**ADDENDUM NUMBER THREE (3)
TO THE PLANS AND SPECIFICATIONS FOR:**

July 3, 2019

**LRGV DC
BUILDING 'D' EXPANSION
Project No. 18.45**

END OF SECTION 072119

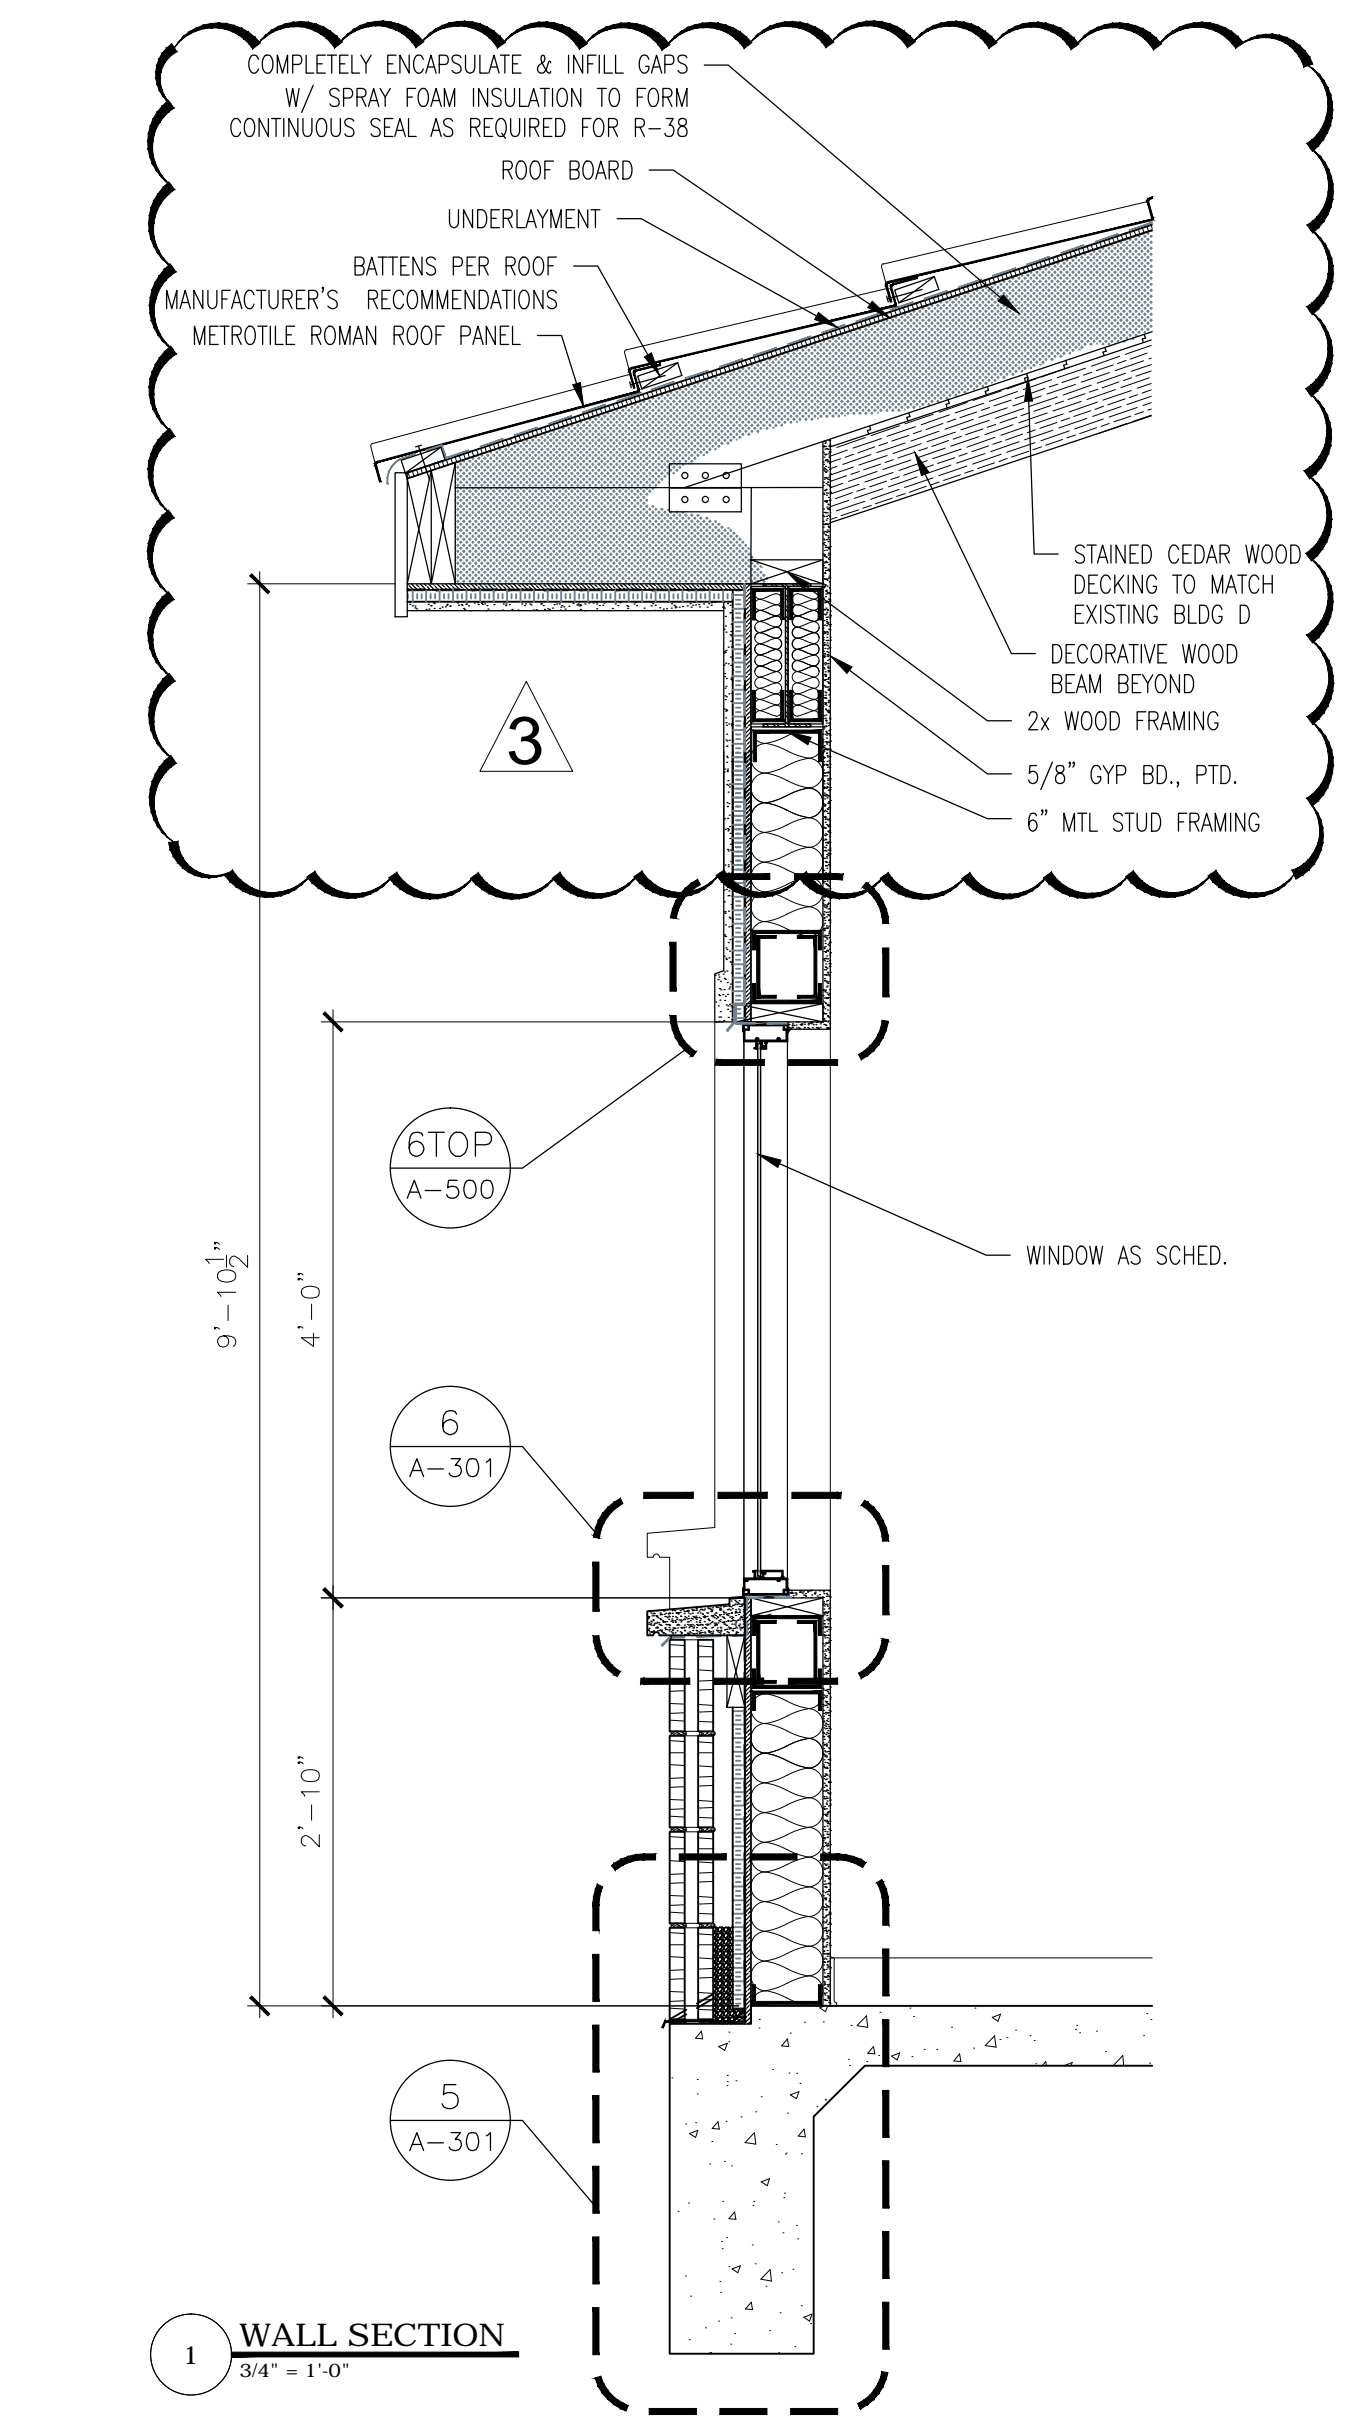
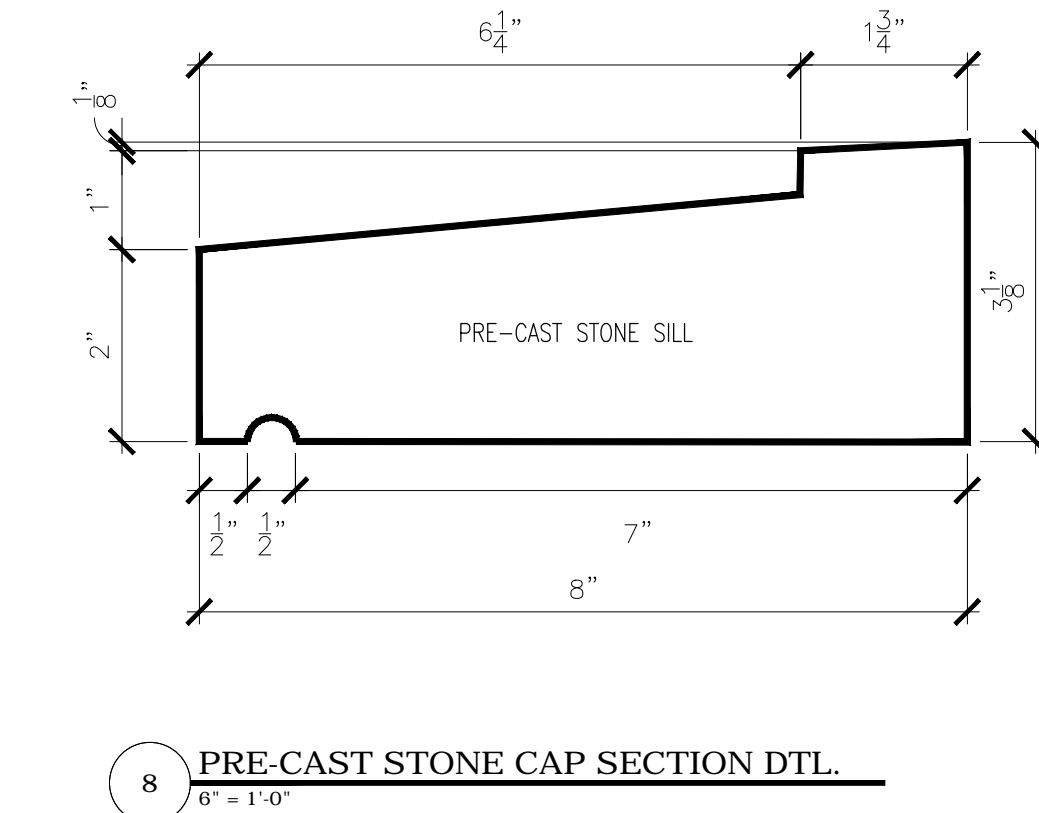
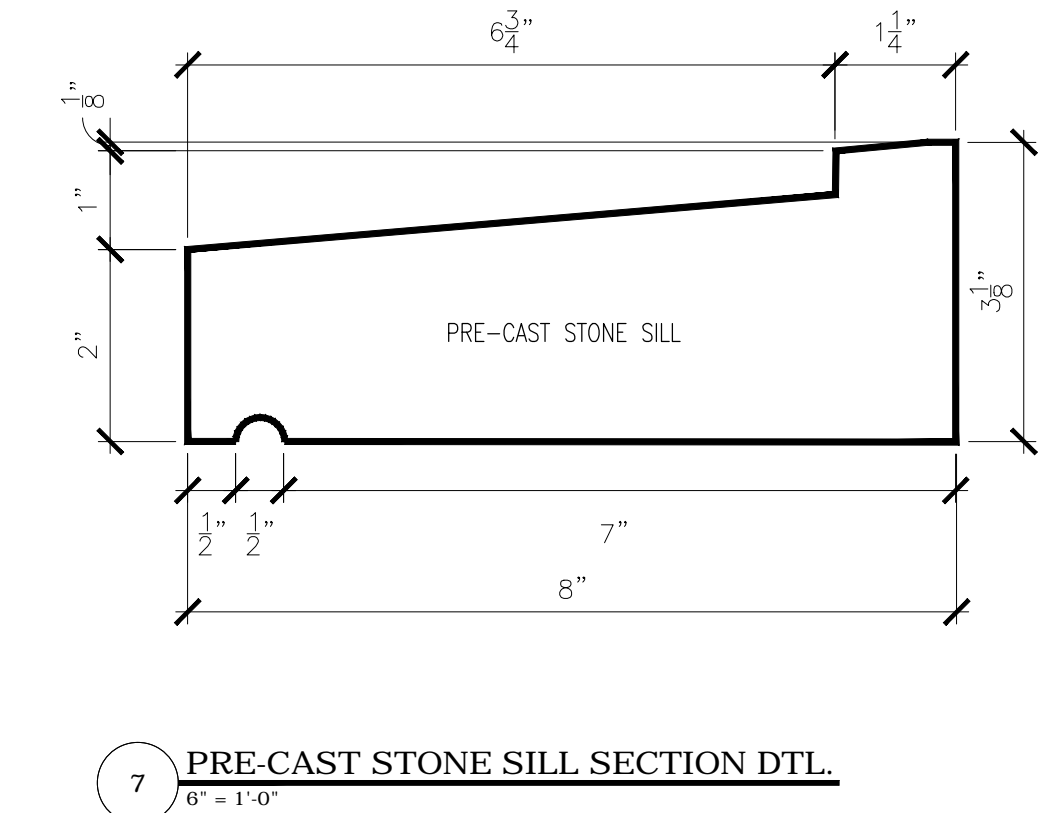
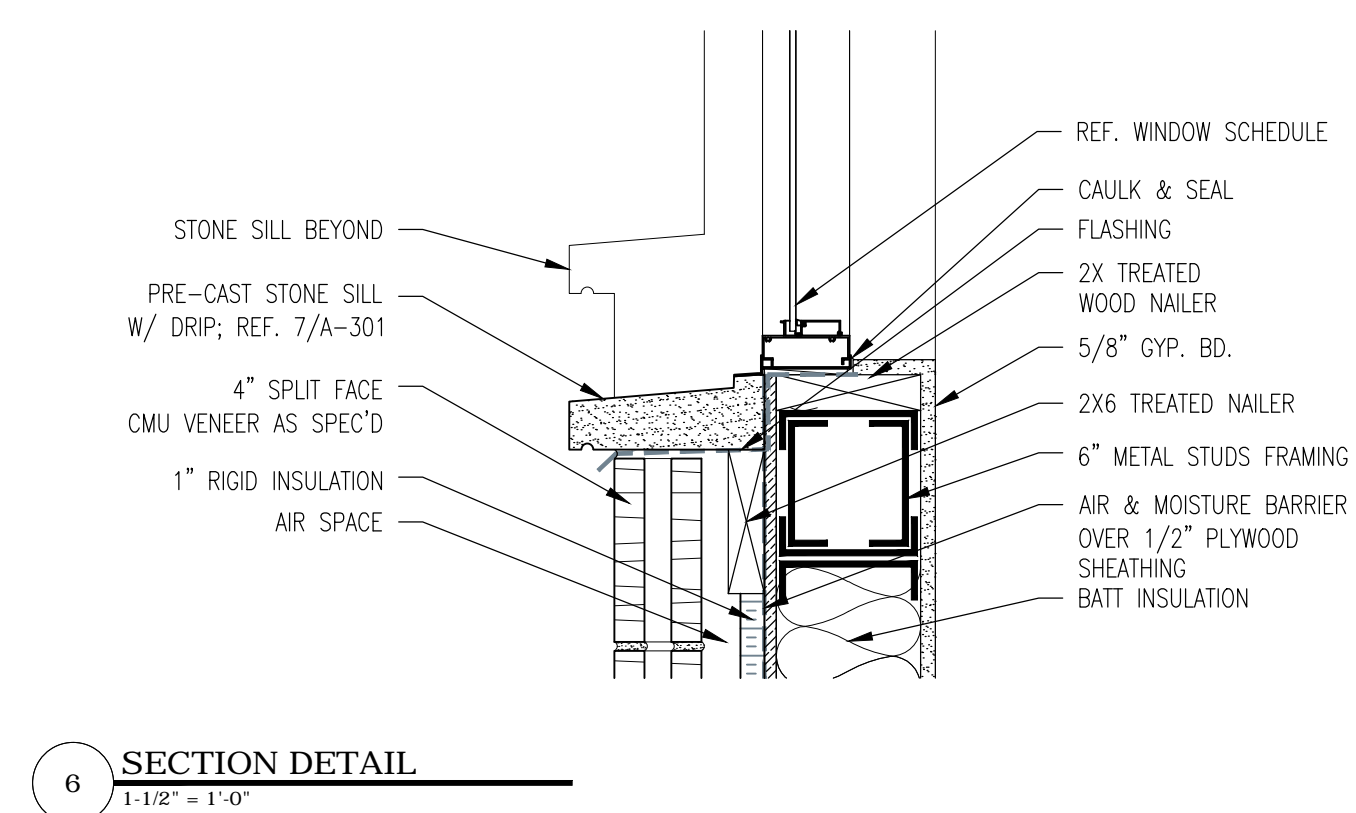
Sheet A-301 Wall Sections

Sheet A-301 Wall Sections in this Addendum shall replace the previously-issued Sheet A-301.
